March 21, 2025

RE: North Hangs Mine, File No., M-2024-059
112c Construction Materials Application
Adequacy Response

North Hangs Mine

C-1 Baseline Conditions

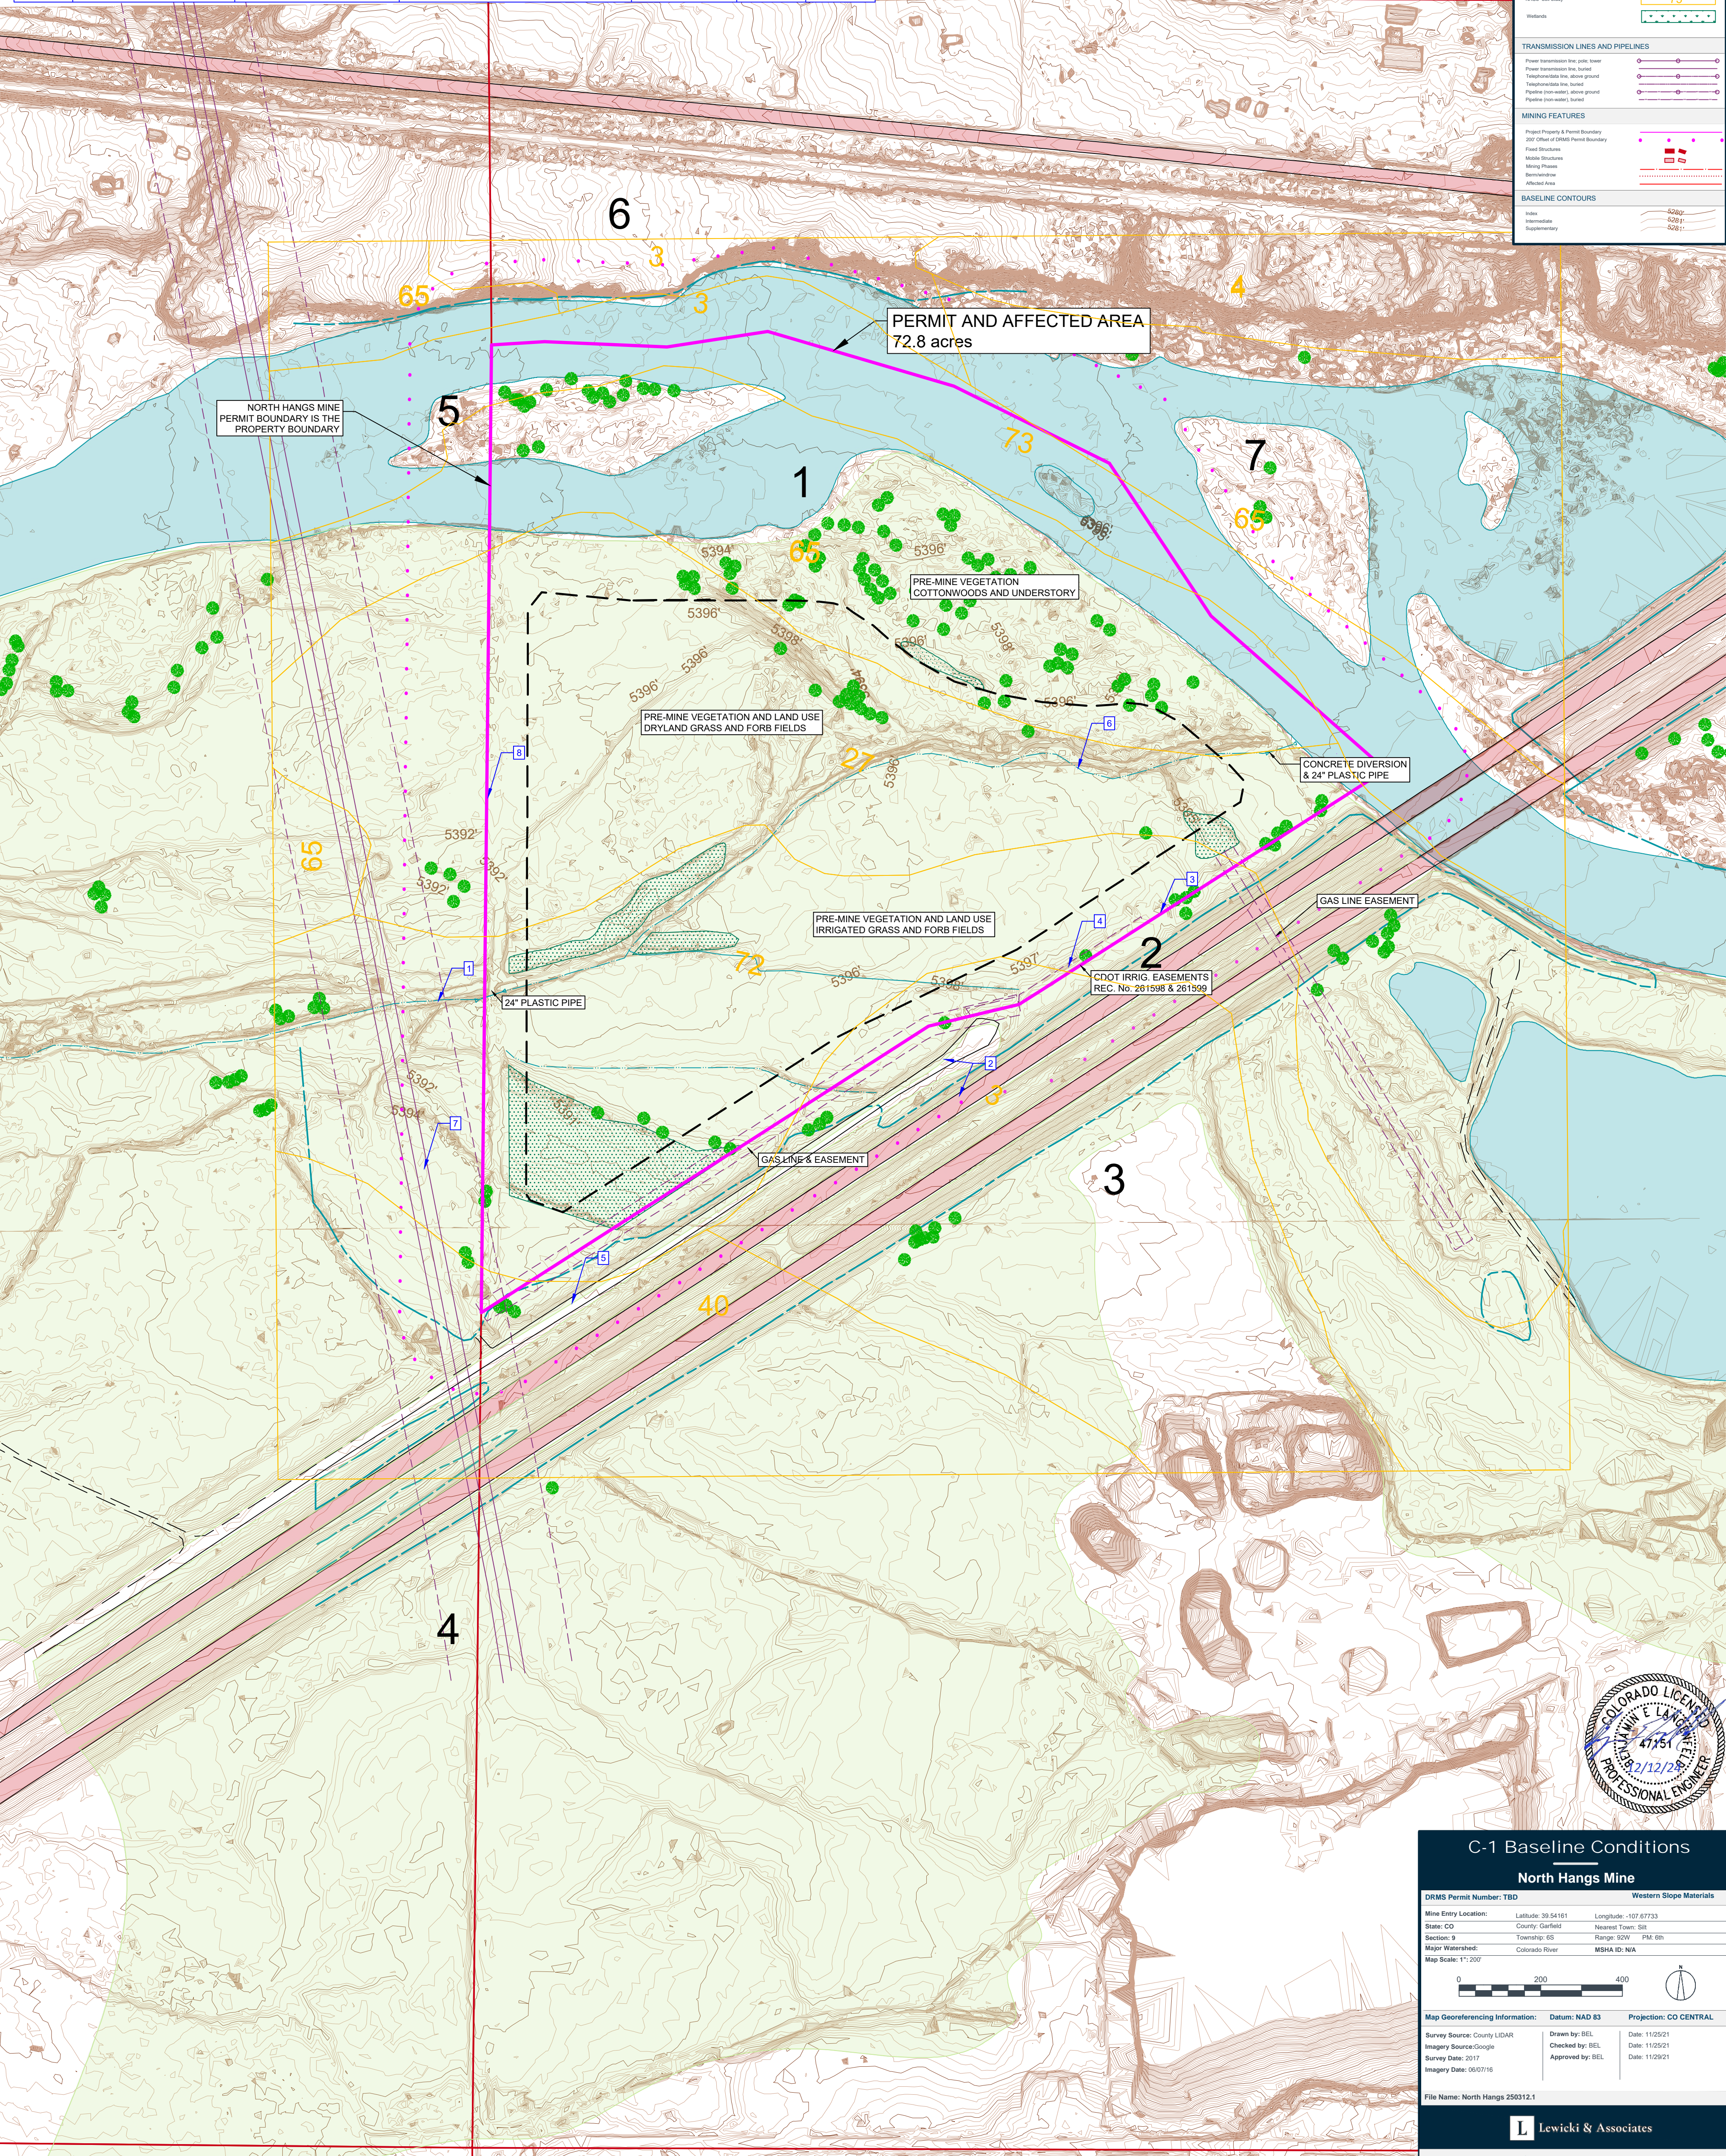
- 2. Per Rule 6.4.3(a) please include the names of adjoining surface owners of record on a map in Exhibit C.*

- 3. Per Rule 6.4.3(g) please show the owner's name, type of structures, and location of all significant, valuable, and permanent man-made structures contained on the area of affected land and within two hundred (200) feet of the affected land. Exhibit S lists 7 structures between 5 owners. All of these structures should be identified.*

- 4. Per Rule 6.2.1(2)(e) please include a north arrow on Map C-1.*

11. Per Rule 6.4.10(1)(b) please include a description or map of the relationship of present vegetation types to soil types.

A table with corresponding labels for surface owners has been added to Map C-1.

A table with corresponding labels for structure owners has been added to Map C-1. Terra Energy's structure agreement certified mail receipt is attached to this response to complete the set.

The north arrow and scale can be found in the Map C-1 title block.

Information has been added to Map C-1 to clarify the relationship of pre-mine vegetation and soil types.

C-4 Mining Snapshot

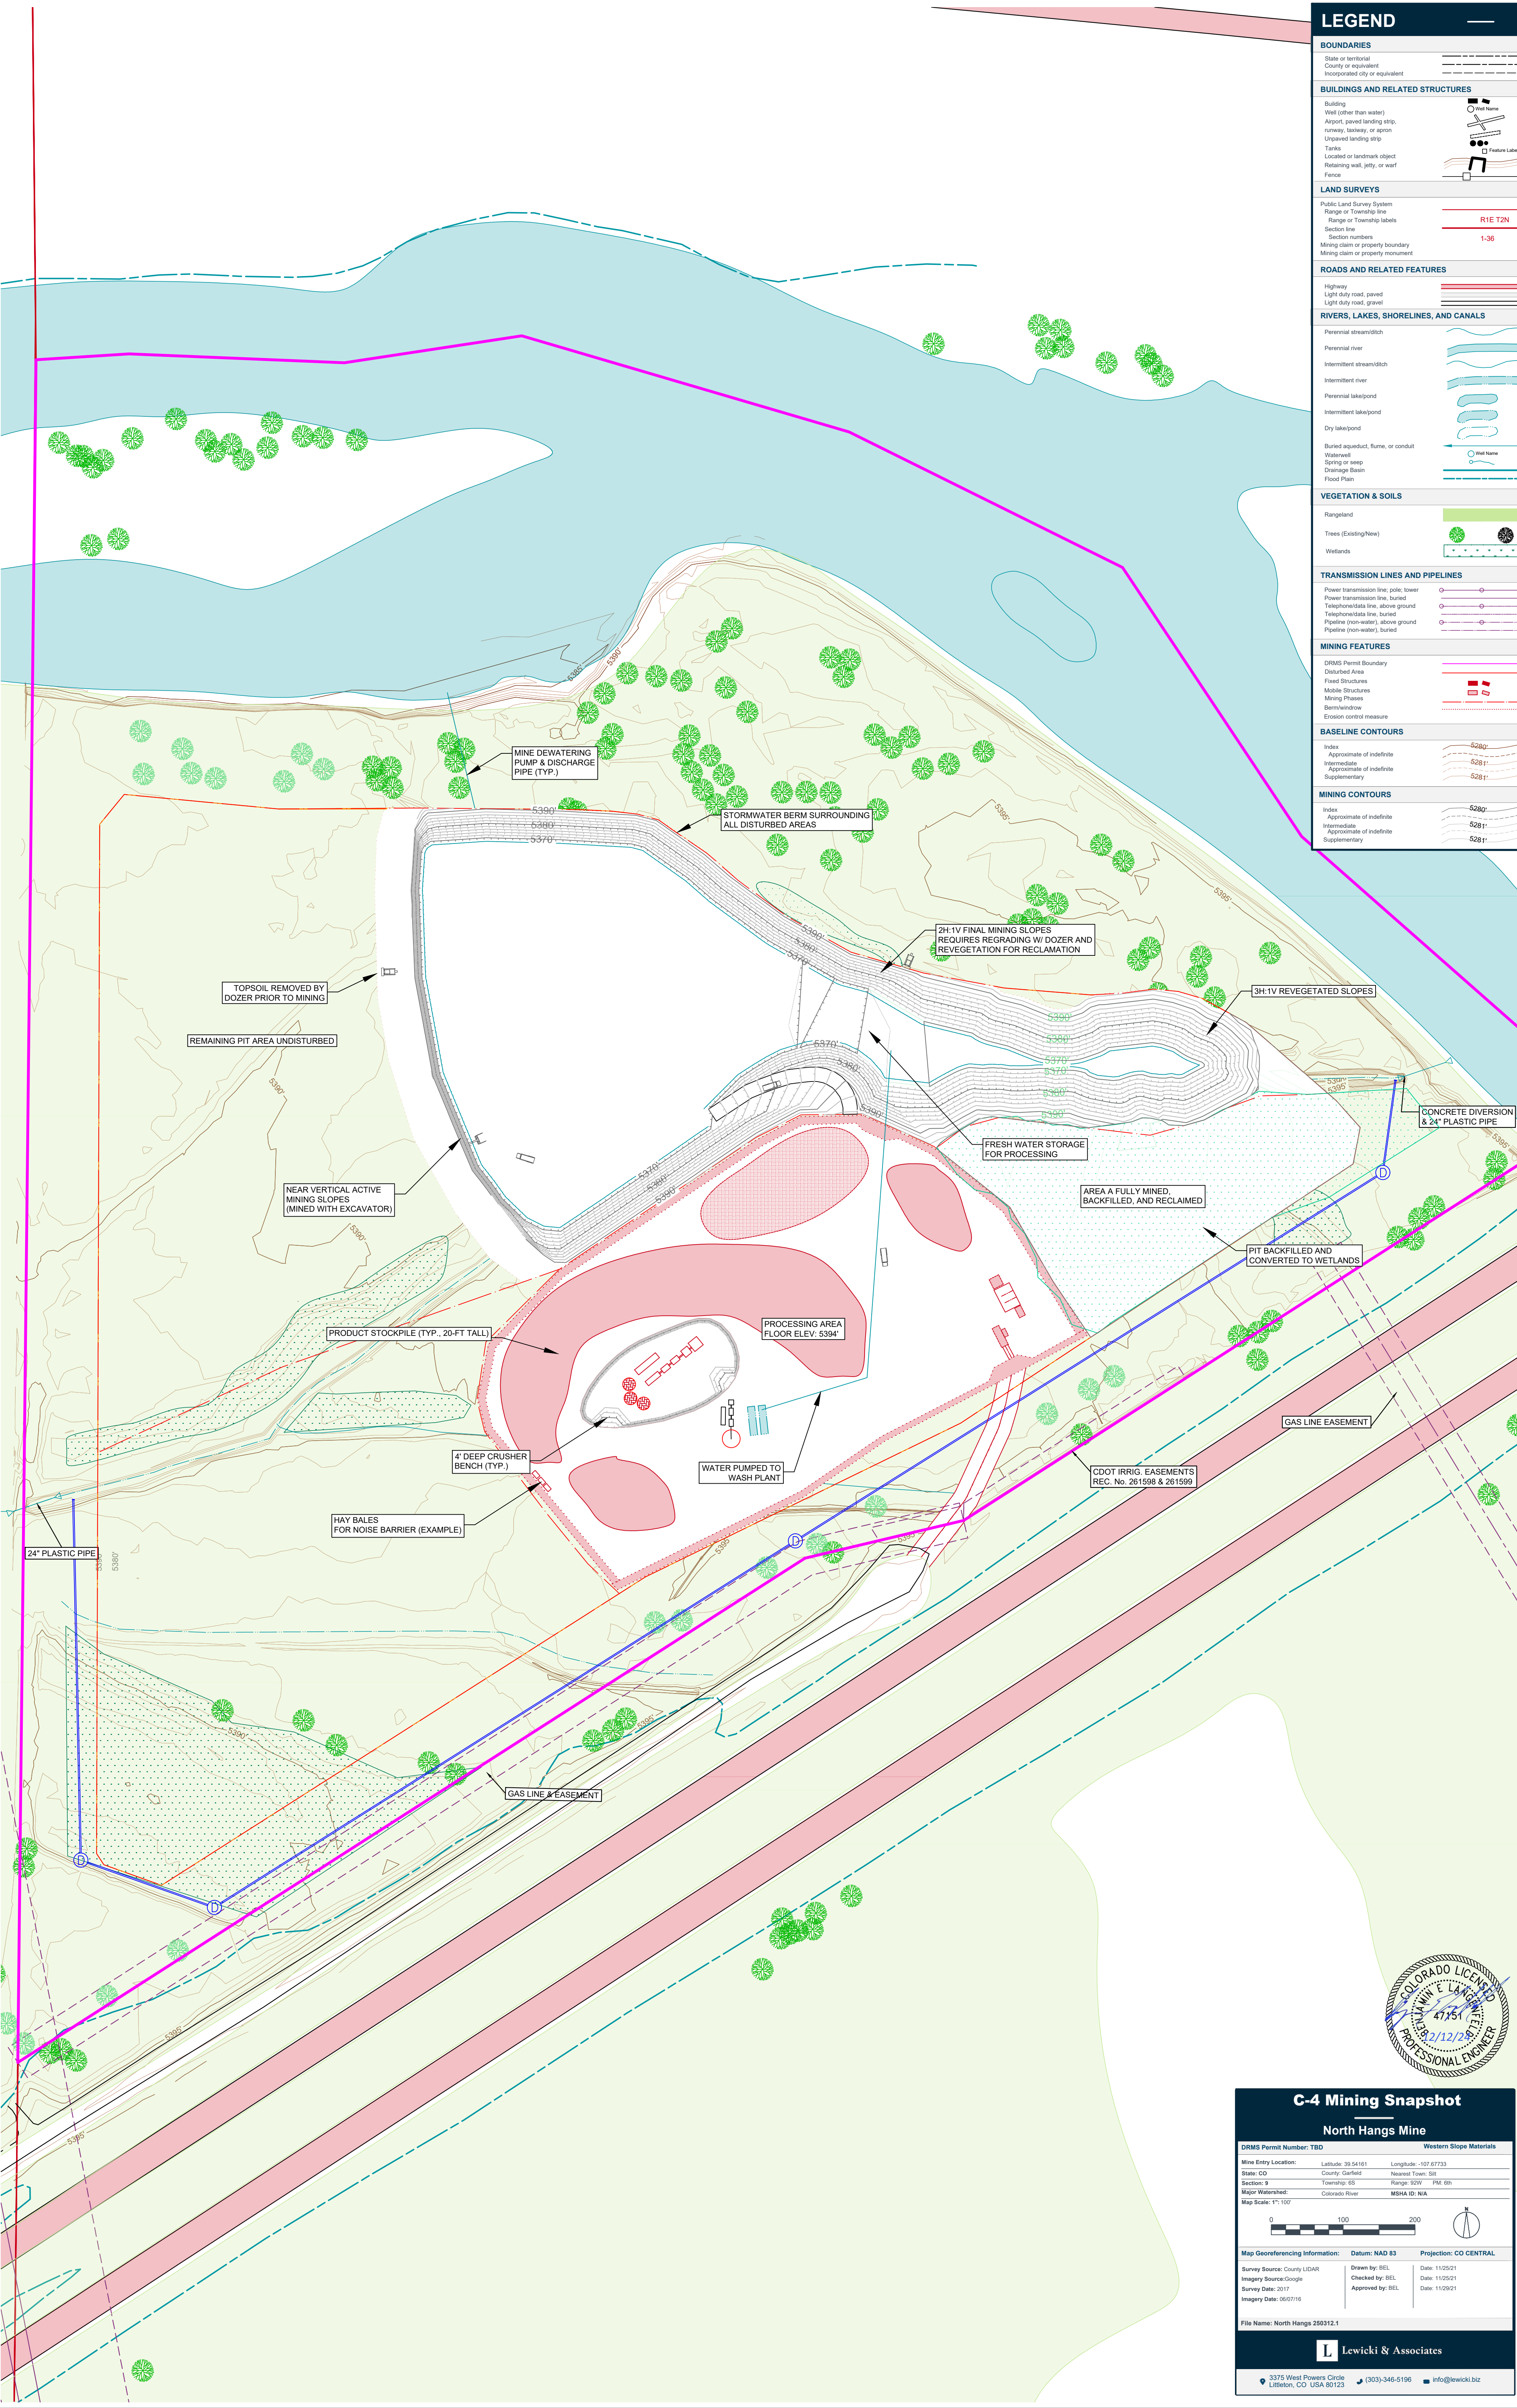
6. *Section 5. Topsoil and Revegetation Plan calls for cottonwood trees to be planted in accordance with Maps F-2 and C-4. However, no Map F-2 was submitted and information on the submitted C-4 does not pertain to tree planting. Per Rule 6.4.5(2)(f)(iv) please specify the quantity size and location of cottonwoods to be planted.*

Map C-4 is attached to this letter. The Map F-2 reference has been corrected to be Map F-1 and the revised page E-3 is attached.

EXHIBIT B LOCATION MAP

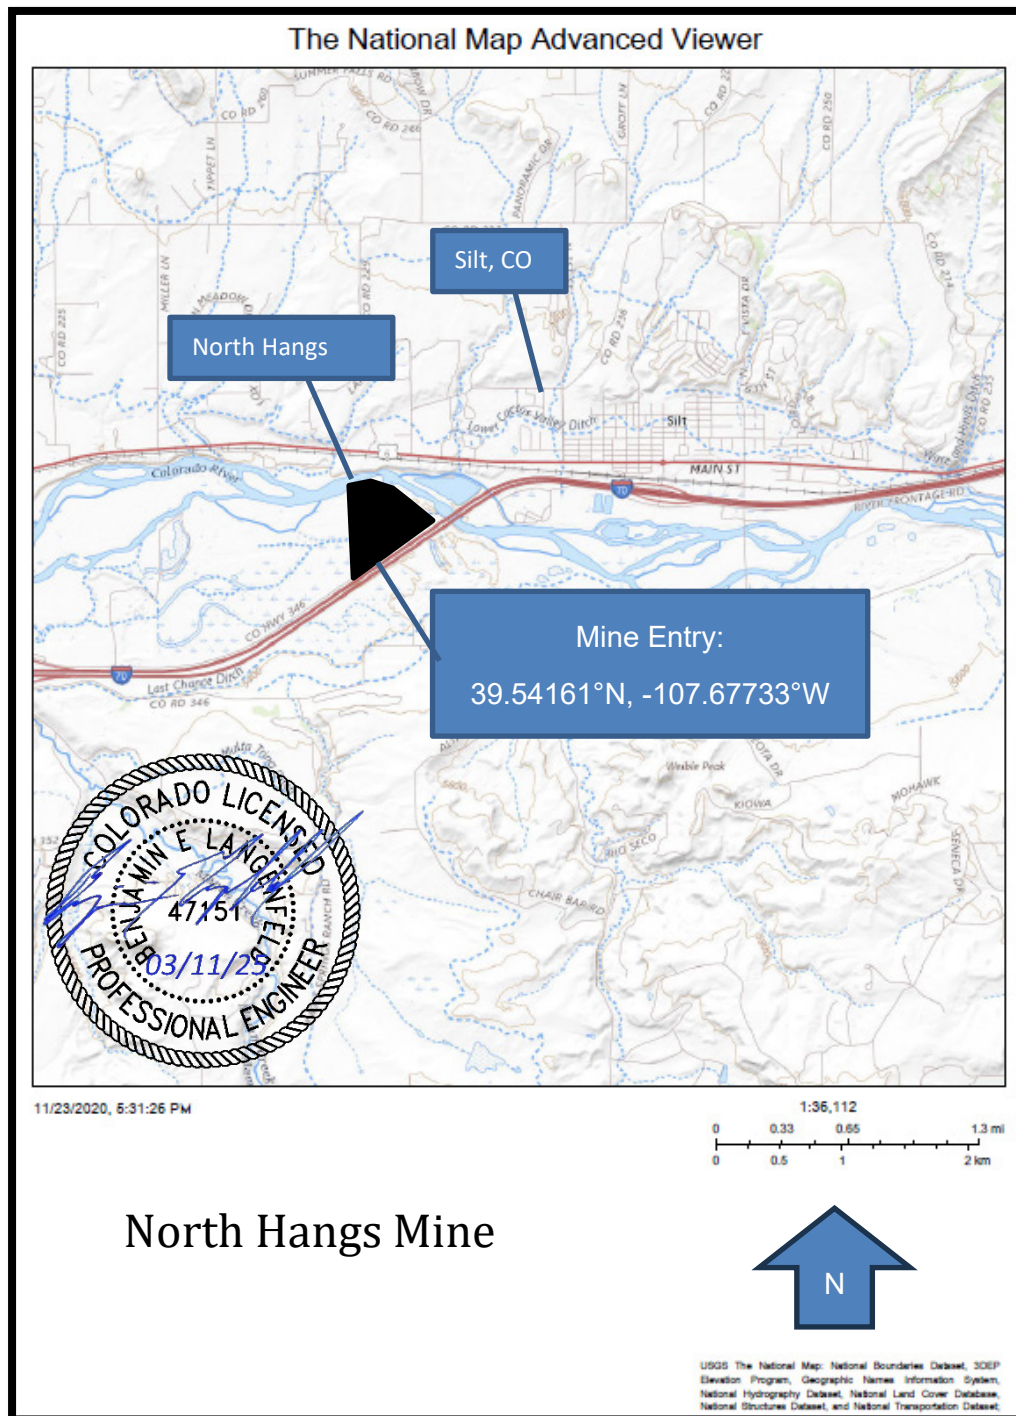
- 1. Per Rule 6.2.1(2)(b) & (e) please include a north arrow and signature on the Location Map.*

Exhibit B has been updated as required.
